**CITY OF NEWPORT BEACH  
COMMUNITY DEVELOPMENT DEPARTMENT**

**Re: Response to Request for Additional Information for the City of Newport Beach**

**Case No.: 12-09-1324S  
Docket No.: FEMA-B-1673**

**Community: City of Newport Beach, CA  
Community No.: 060227**

**Figure 1.      Example Seawalls**

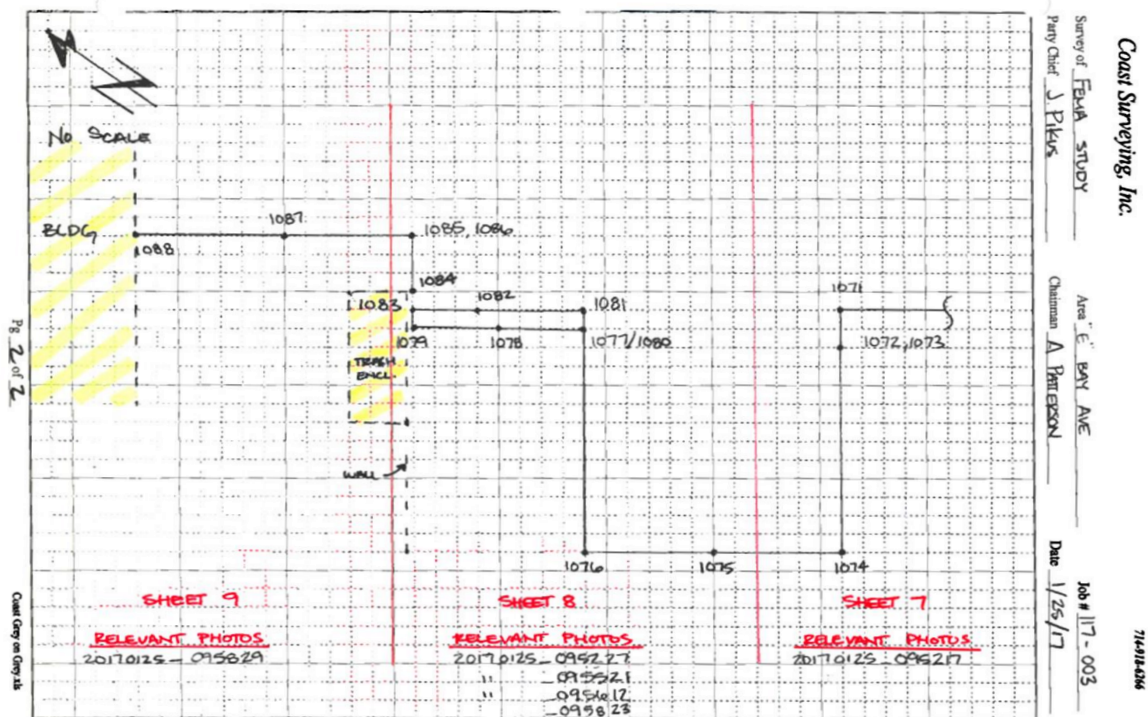
*Submitted raster data for the seawalls around Newport Bay do not accurately represent conditions on the ground for the following reasons:*

- *Survey data point density is very low with considerable interpolation between survey points. Higher density of survey points for individual seawalls is needed to interpolate between points, particularly in areas where individual seawalls for each property are present.*
- *The width of the seawall crests in the raster dataset is about 20 ft. Whereas the actual width of the seawall crests is generally less than 5 ft.*

*Please modify the seawall raster dataset used in the HEC-RAS model to accurately represent ground conditions.*

The objective of the survey is to identify the location and height of the seawalls for the use of the HEC-RAS model to simulate flood extent in Newport Bay. As shown in Figure 1 (attached), most of the seawall segments along the shoreline of Balboa Island and Newport Bay are straight and of uniform heights and can be captured by two survey points at the two ends of a seawall segment. Hence, the density of the survey points is sufficient to meet the objective. The survey team kept very detailed field notes and photos to ensure all the necessary detail of the seawall was captured. Example survey field notes and photos are provided in Figures 2 and 3 (attached). Nevertheless, the City has retained Coast Surveying to conduct an additional survey, which added 1,427 survey points of the seawall elevations. The top of wall elevations were extracted from digital models developed from 1"=20' scale photogrammetric mapping. The locations of these new surveys points are shown in Figure 4 (attached). In Figure 4, the previously submitted survey points conducted in 2017 are also shown. A reference of the data points is shown in the attached Seawall Survey 2018 Map. The following link shows the data points that were referenced in 2017 as submitted to FEMA as well as the new additional data collected in 2018; when zoomed you will be able to see the elevation labels turn on:

The HEC-RAS model simulates flow overtop the seawall using a weir formula and the cell width of approximately 20 ft. shown in the raster dataset is irrelevant. The cells along the seawalls are only used to define the locations and heights of the seawalls. Since we are setting up the HEC-RAS model to simulate the entire Newport Harbor and Bay, we try to limit the cell size to be not smaller than approximately 20 ft. to reduce simulation time. Reducing the cell size along the seawall to approximately 5 ft. will not affect the model simulated flood extents.

**Figure 7. Comparison of Water Surface Elevation Results at Dover Shore for June 11-12, 1992 & June 23-24, 1992 (HEC-RAS results shown in blue & red-orange, original USACE results shown in black)**

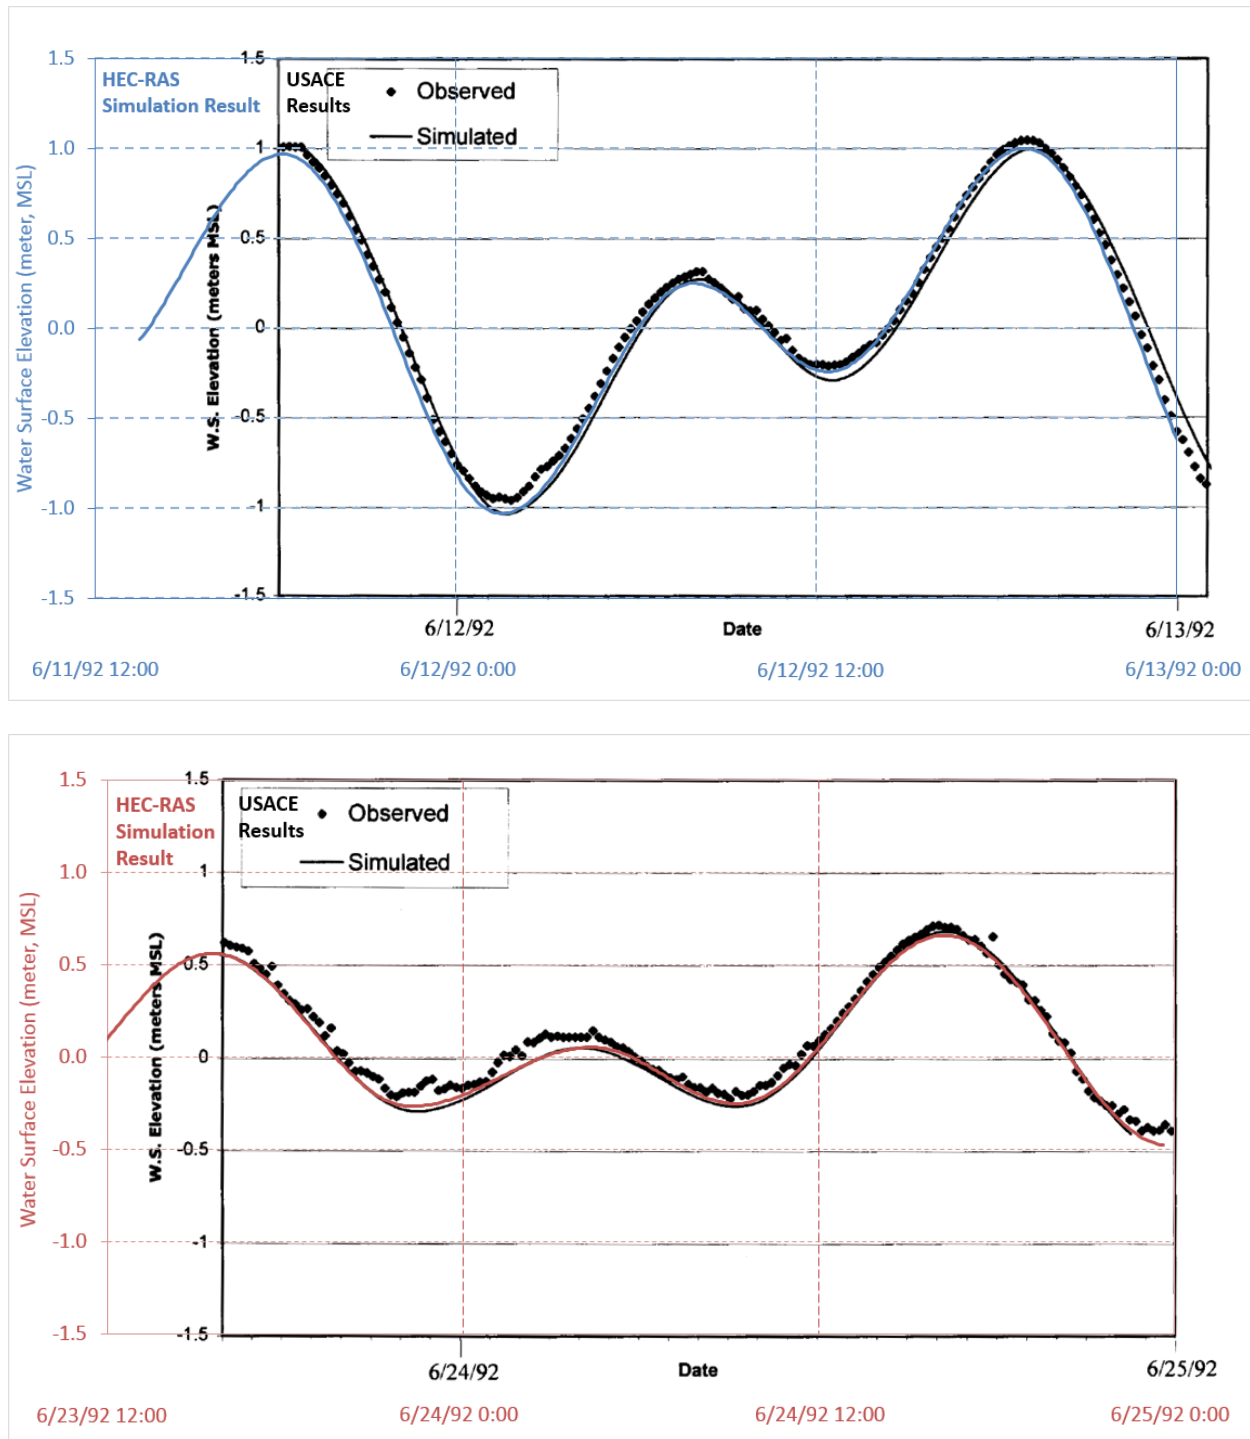
*The Newport Bay HEC-RAS model was validated qualitatively by looking at flood extents for the January 10, 2005, flood event. Please provide additional model validation to ensure accuracy of the HEC-RAS model using historic water level observations in Newport Bay. Below are a few examples of data sources that may be used to complete this validation.*

- *NOAA hourly tide data from the Newport Bay Entrance Channel (Station ID 9410580) from 1979-1994.*
- *US Army Corps of Engineers (USACE), Los Angeles District, Upper Newport Bay Model Development- Baseline Conditions Analysis, 1998. This study validated an RMA hydrodynamic model of Newport Bay using observed water level data from 1992 at various locations around the bay.*

The comparison of the HEC-RAS model with an actual flood event is to validate the capability of the model to simulate flooding in a coastal urban area due to overtopping of seawall. Generally, any two-dimensional hydrodynamic model such as the HEC-RAS model can accurately simulate water elevations in open water due to tidal action. The following illustrates the accuracy of the HEC-RAS model in simulating water elevations in the open water of Newport Harbor using the recommended data source (USACE 1998).

In the 1998 U.S. Army Corps of Engineers (USACE) Feasibility Report on Upper Newport Bay Numerical Model Development: Baseline Conditions Analysis, model results were compared with data from two tide gage stations. These stations are situated at Dover Shores and salt dike. Only data from Dover Shore was used in our modeling efforts to compare HEC-RAS model results with the field data. This is because since the USACE study was completed, the salt dike area has undergone extensive restoration and dredging as a part of the Upper Newport Bay Ecosystem Restoration Project—and now has completely different bathymetry. The Dover Shore data consisted of observed and simulated water surface elevations for June 11-12 and June 23-24, 1992. A comparison of the USACE data and our modeling results at Dover Shore show an almost exact match for water surface elevations, as presented in Figure 7. Specifically, the Figure includes a comparison plot for each of the two data timeframes, while each of these individual plots compares RMA modeling results from the USACE study, our HEC-RAS modeling results, and observed data from the USACE study. As such, the close match between the USACE data and our results provides additional model validation for ensuring accuracy of the HEC-RAS model used in our analyses.
